Architect's Supplemental Instructions

Architect's ASI No: 035

Project:
Webster University
Interdisciplinary Science
Building

Discipline Code: 03 Electrical

LEVEL 02 AREA B FLOOR PLAN - ELECTRICAL & AUXILIARY

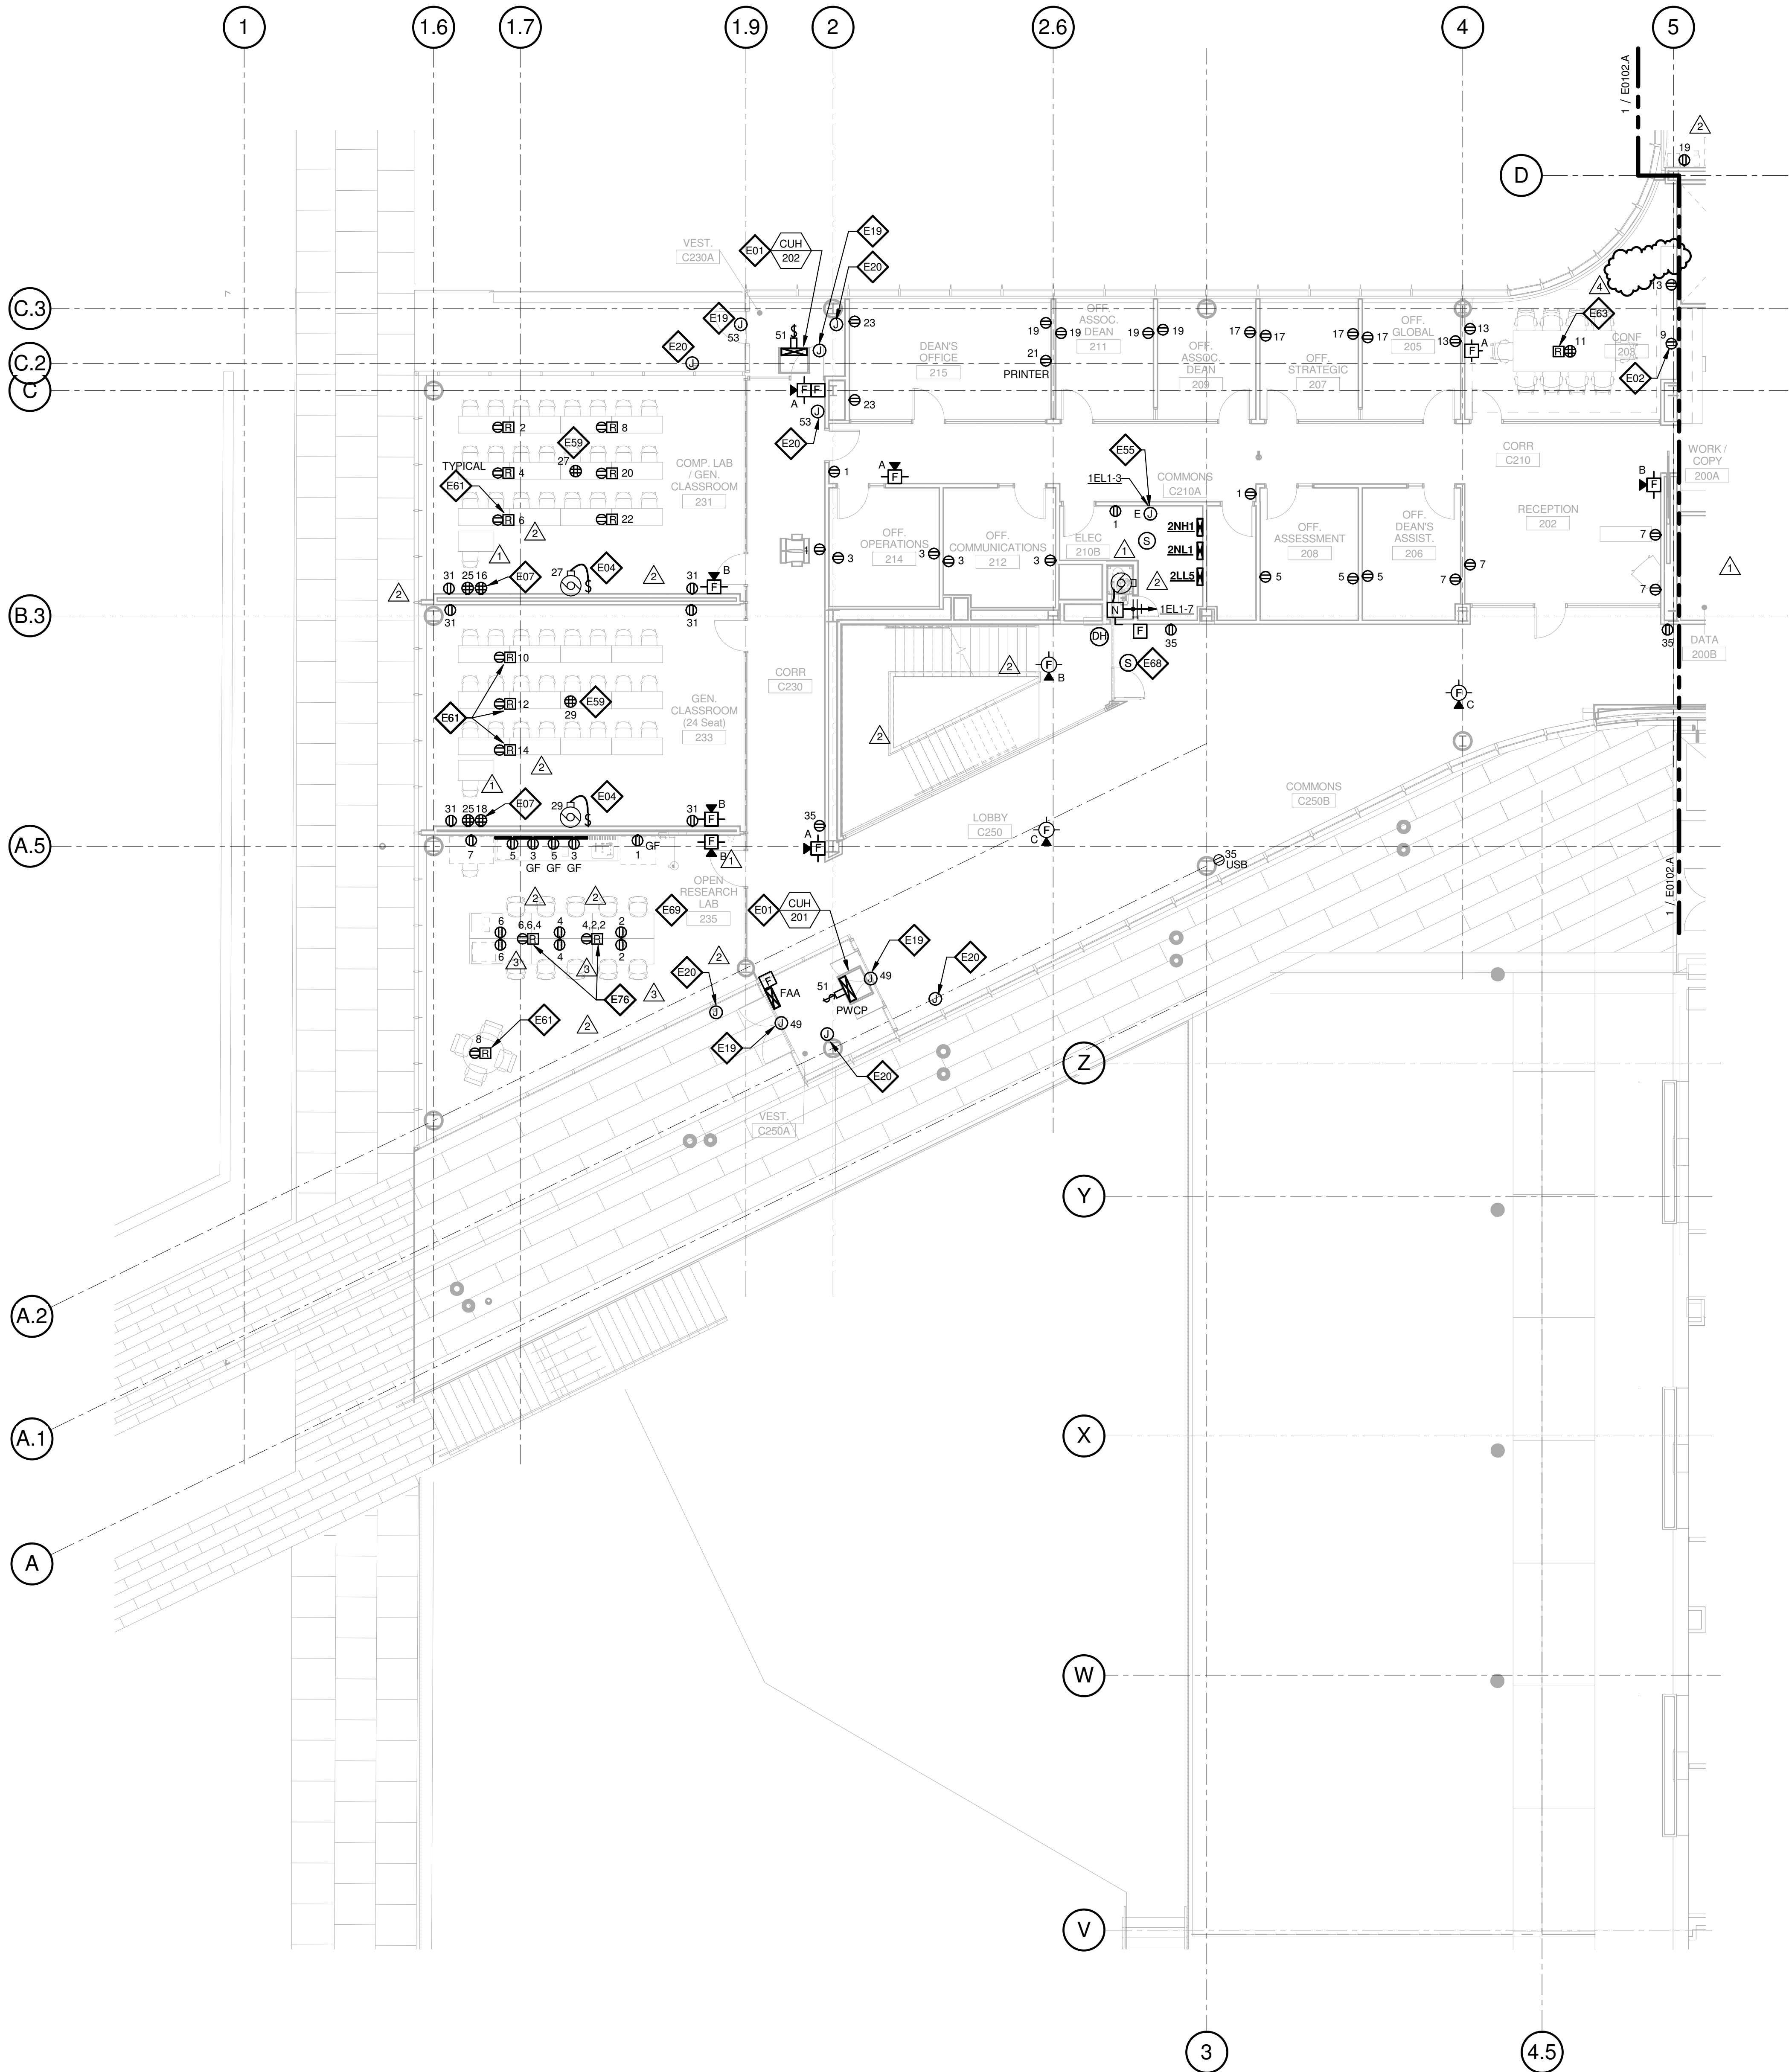
- Delete AV rack quadruplex receptacle and associated circuit in Conf 203.

LEVEL 03 AREA A FLOOR PLAN - ELECTRICAL & AUXILIARY

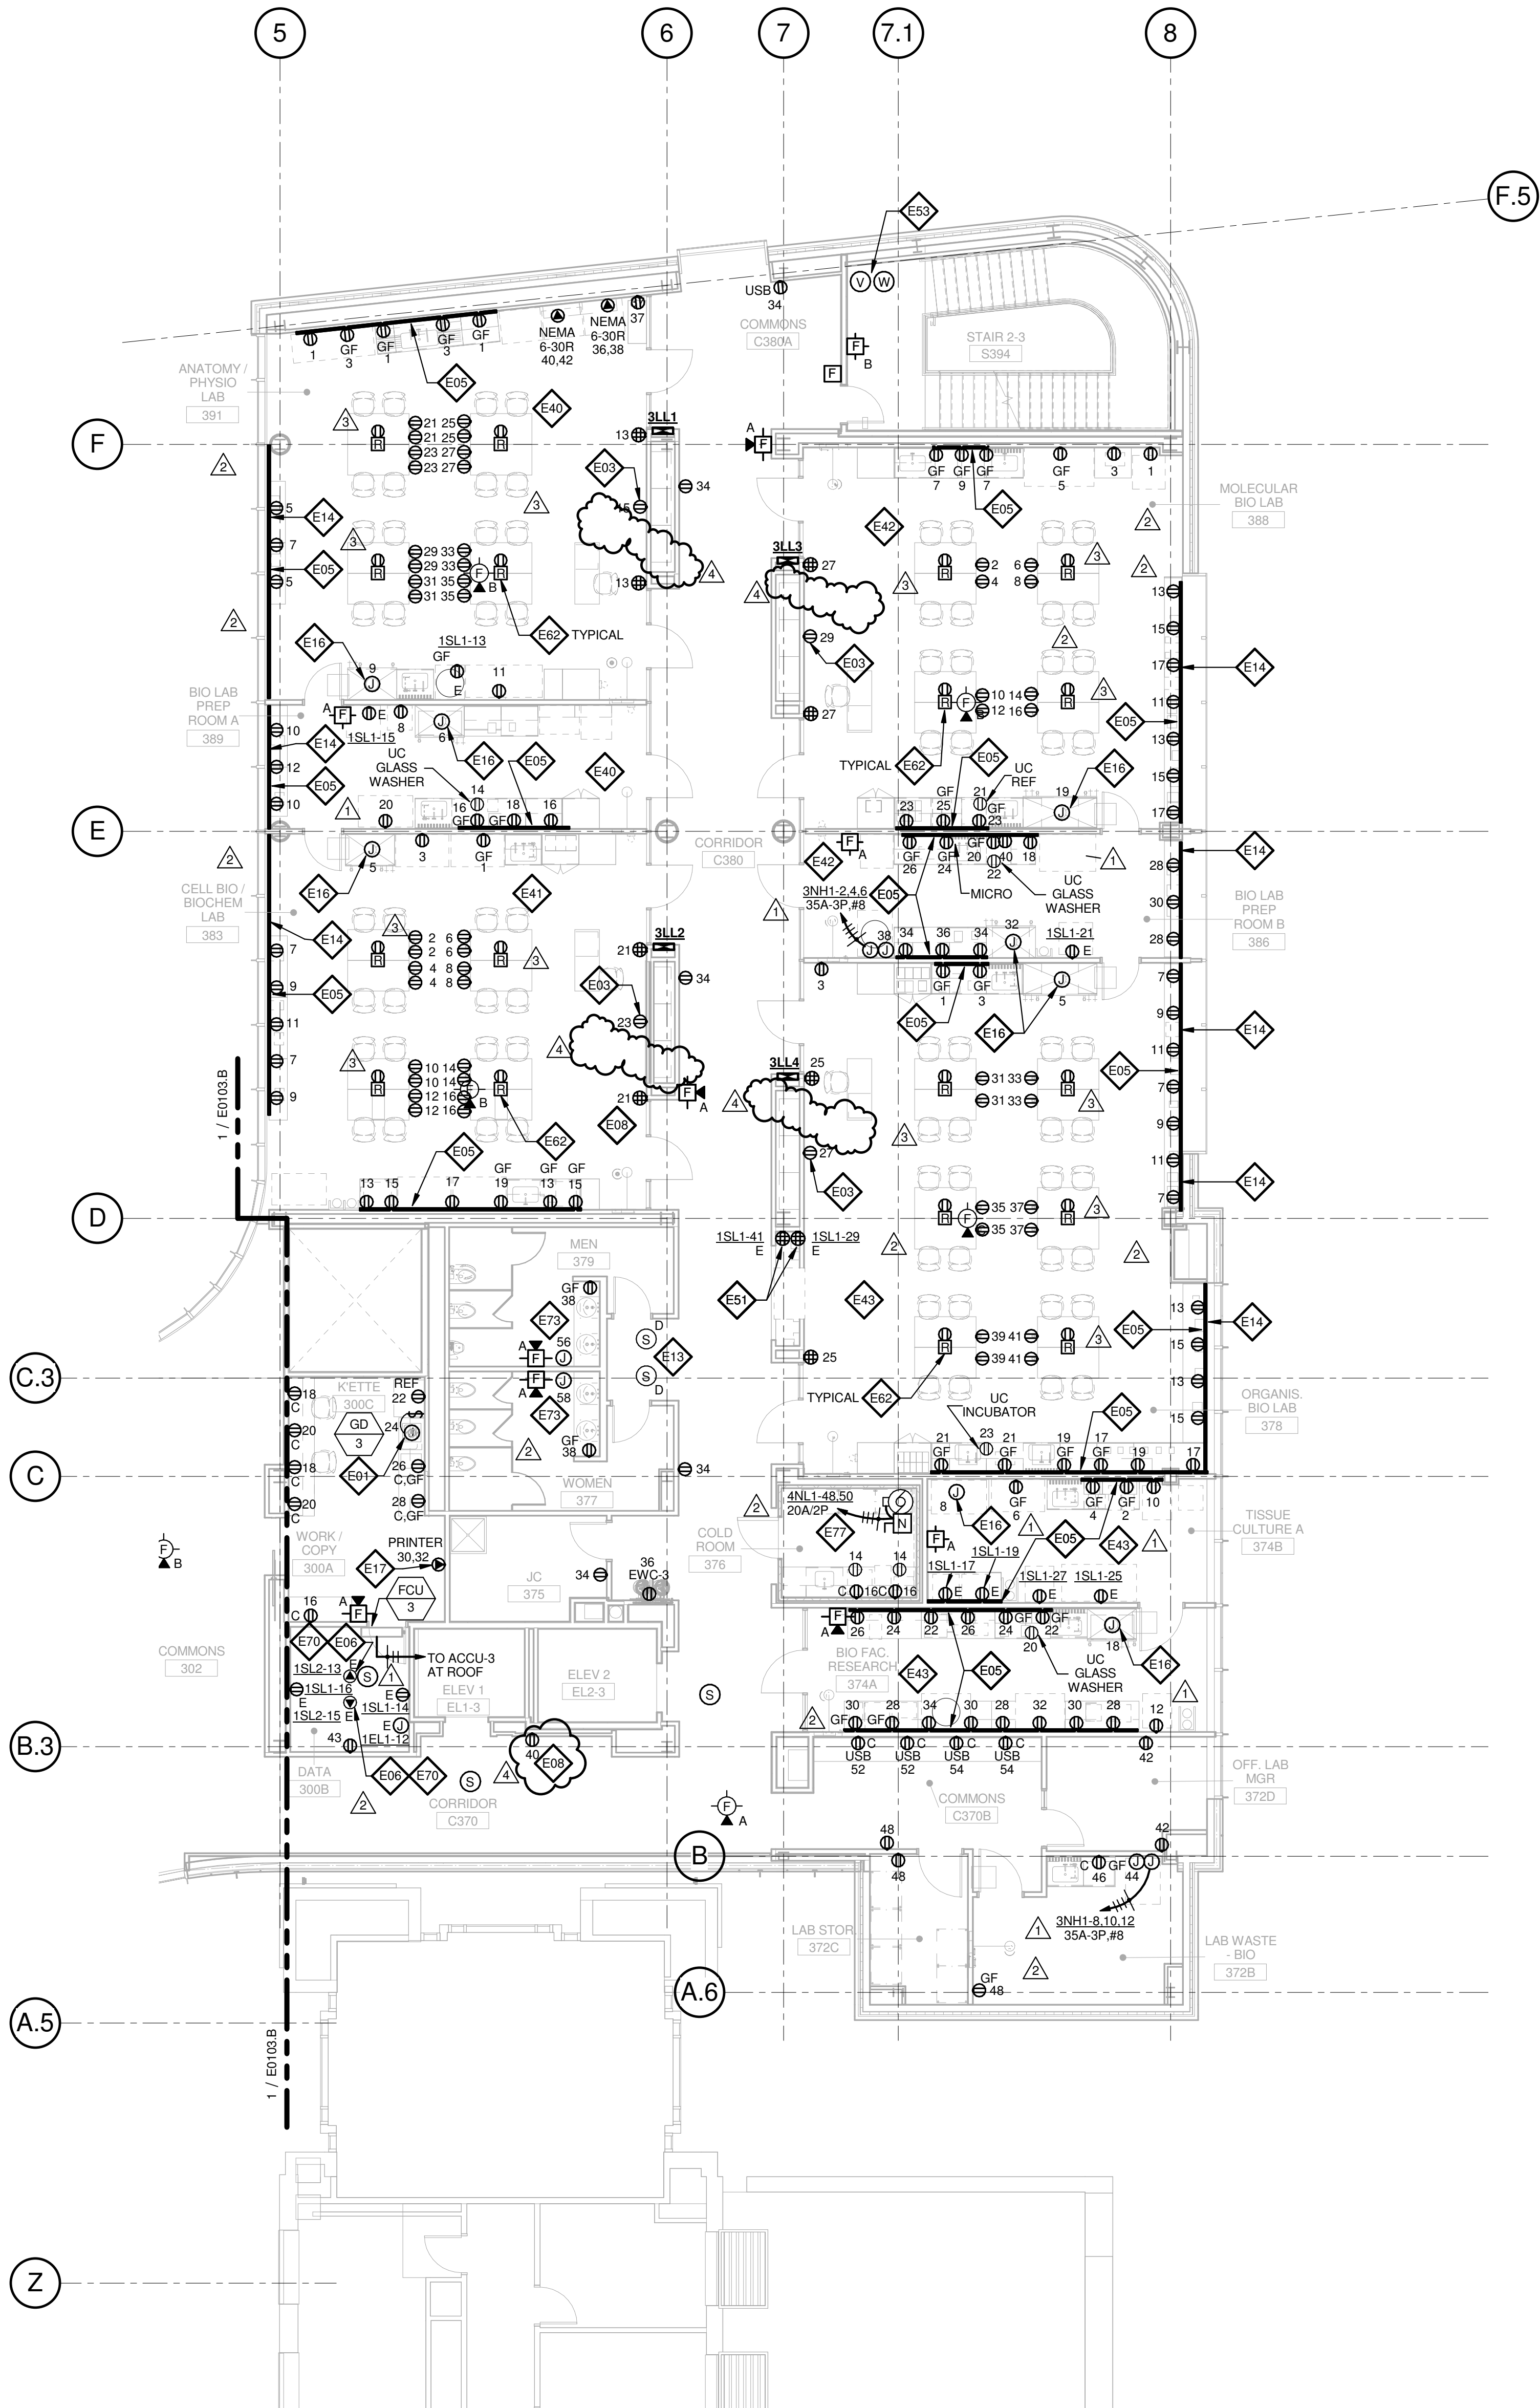
- Delete AV rack quadruplex receptacle and associated circuit in Lab 378.
- Delete AV rack quadruplex receptacle and associated circuit in Lab 383.
- Delete AV rack quadruplex receptacle and associated circuit in Lab 388.
- Delete AV rack quadruplex receptacle and associated circuit in Lab 391.
- Add Keyed Note E08 to receptacle in Corridor C370.

LEVEL 03 AREA B FLOOR PLAN - ELECTRICAL & AUXILIARY

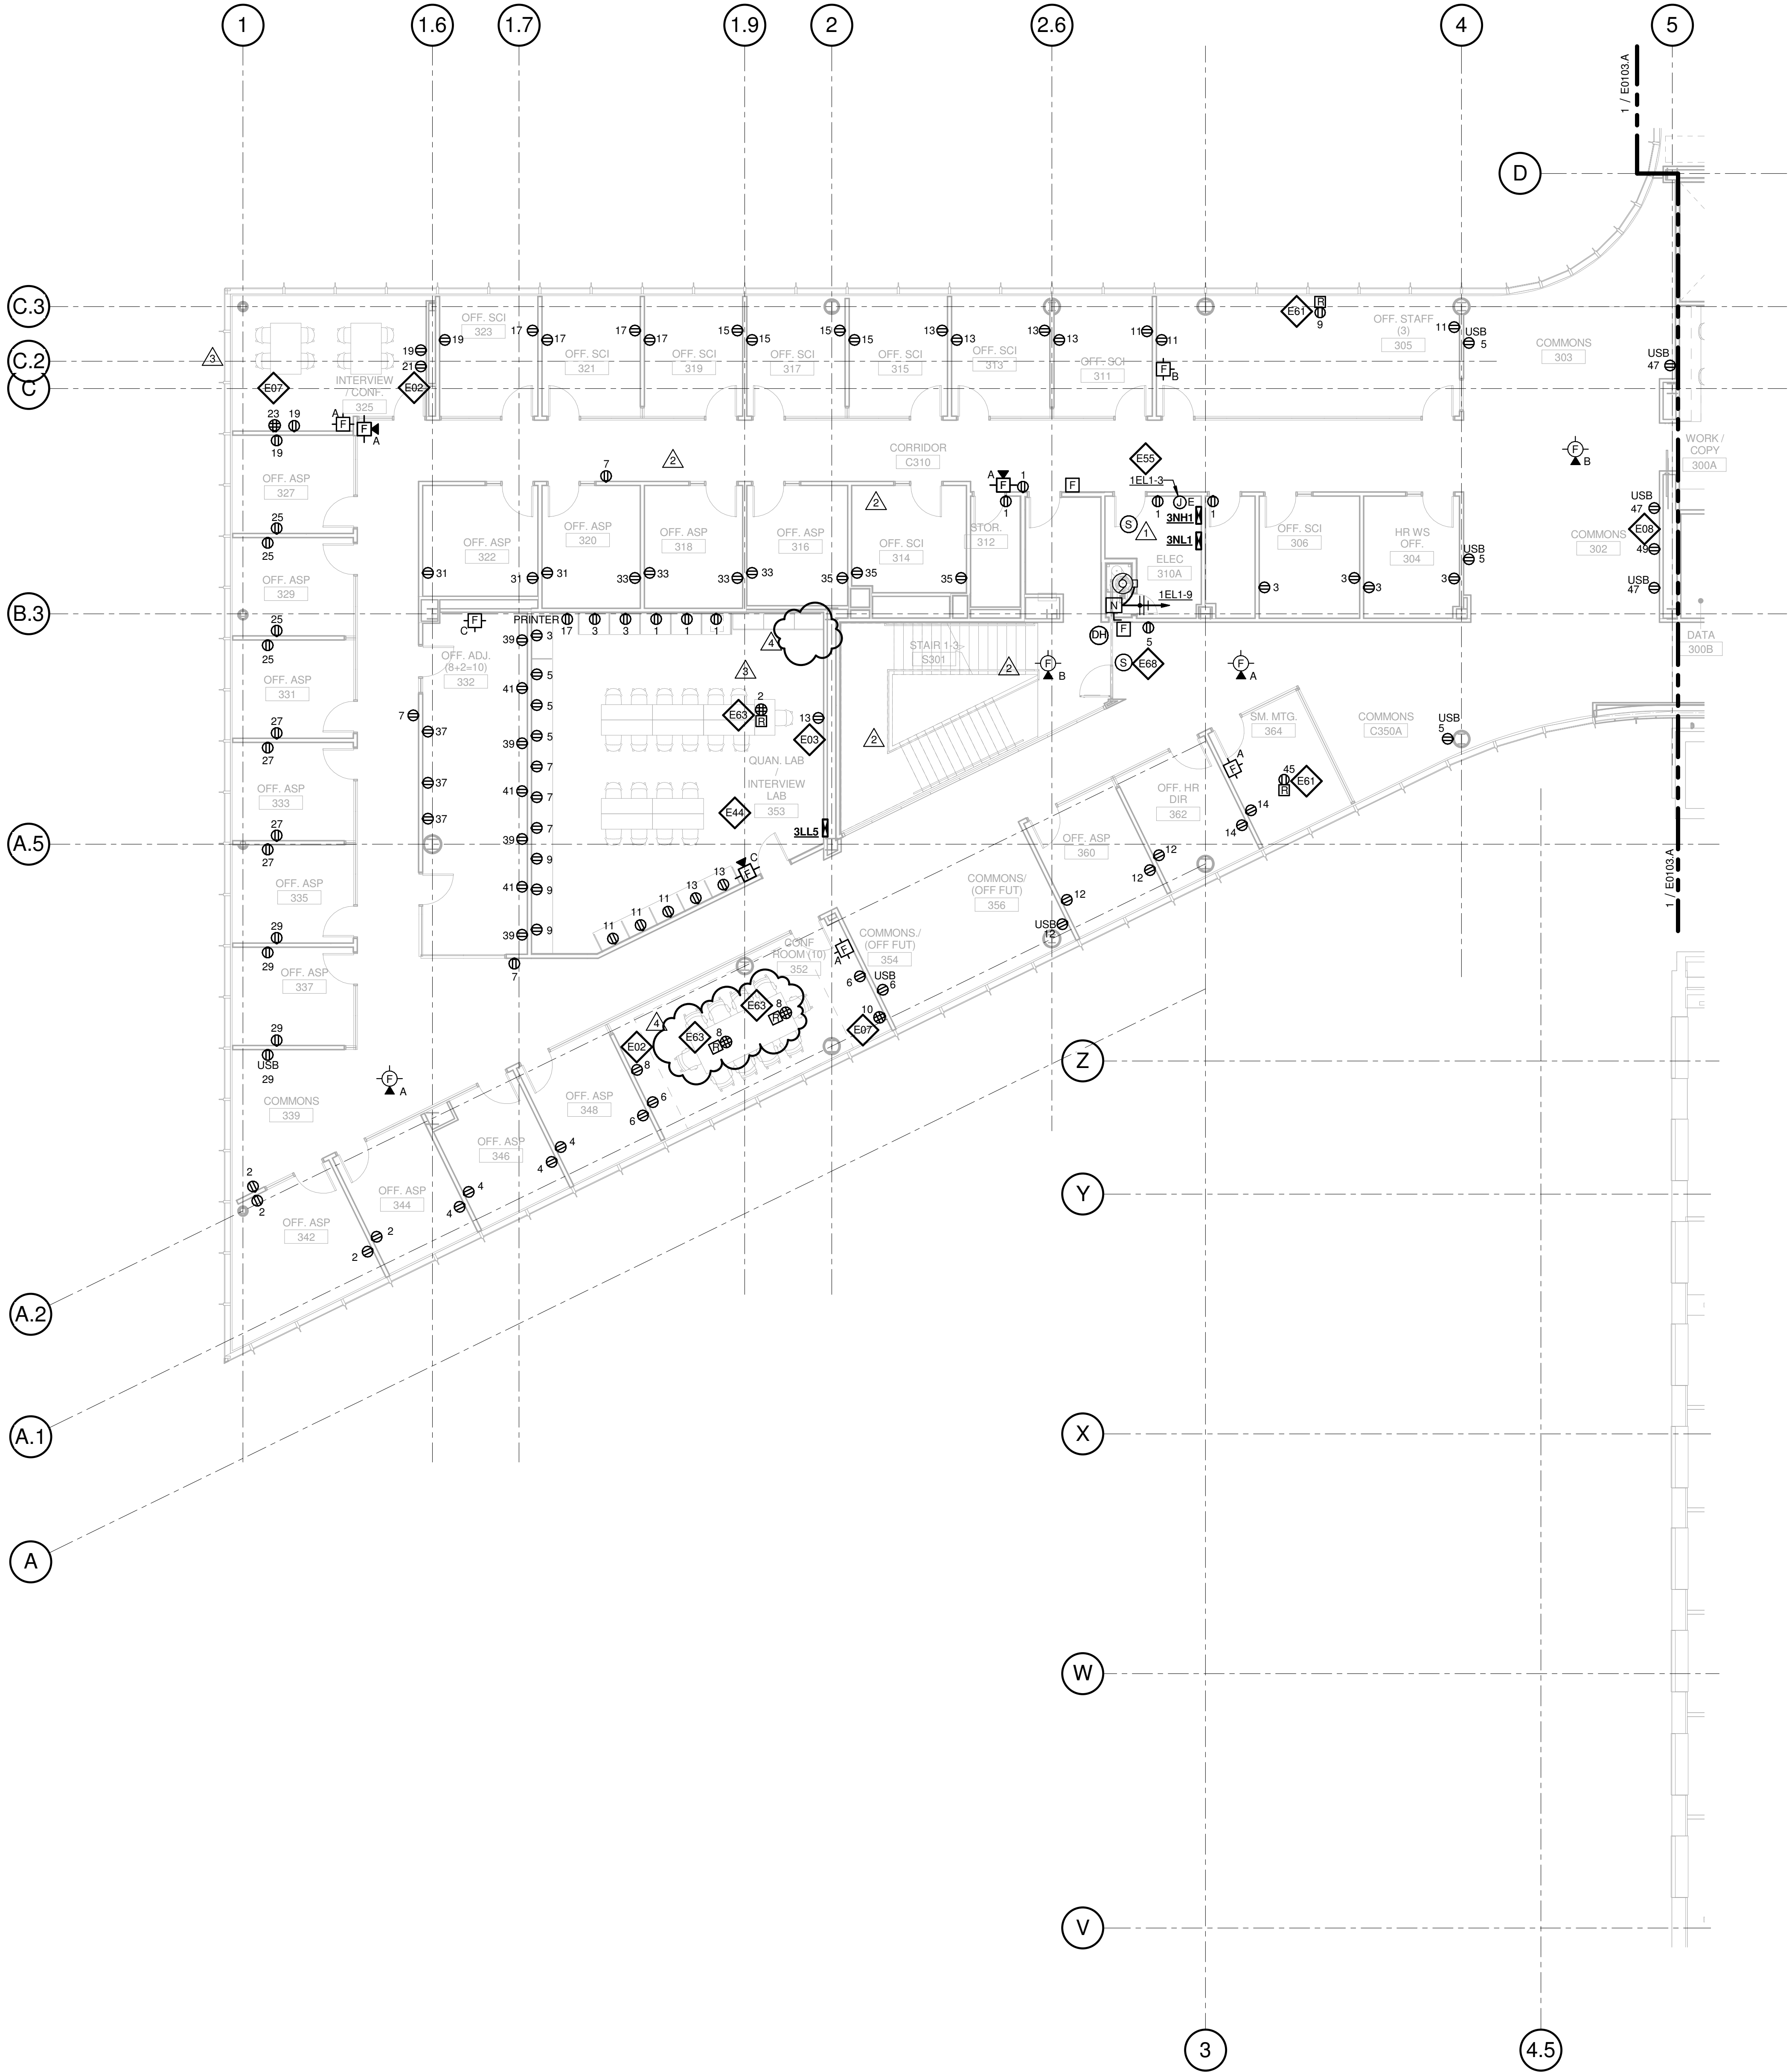
- Delete AV rack quadruplex receptacle and associated circuit in Lab 353.
- Add floor box in Conf 352 and connect to circuit serving adjacent floor box.
